# SERVICE LETTER

**No. 637**

Subject:

Rajay Service Letter No. 19, dated September 5, 1972.

SERVICE LETTER No. 19

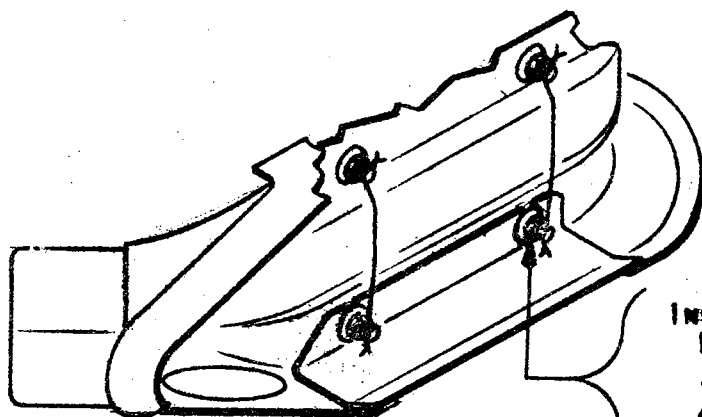
THERE HAVE BEEN ISOLATED REPORTS OF THE TURBOCHARGER INDUCTION DUCT RETAINING STUDS BACKING OUT AND BEING INGESTED INTO THE COMPRESSOR SECTION OF THE TURBOCHARGER. TO PRECLUDE THIS FROM OCCURRING ON ANY FUTURE INSTALLATIONS, A REVISED ASSEMBLY WILL BE USED AS SHOWN BELOW:

INSTALL:  
NAS 183-4-8 STUD  
AN 310-4 NUT  
4 EACH REQUIRED  
SAFETY WIRE (.030 DIA.) PER  
MS 33540 TOP TO BOTTOM AS SHOWN  
2 PLACES
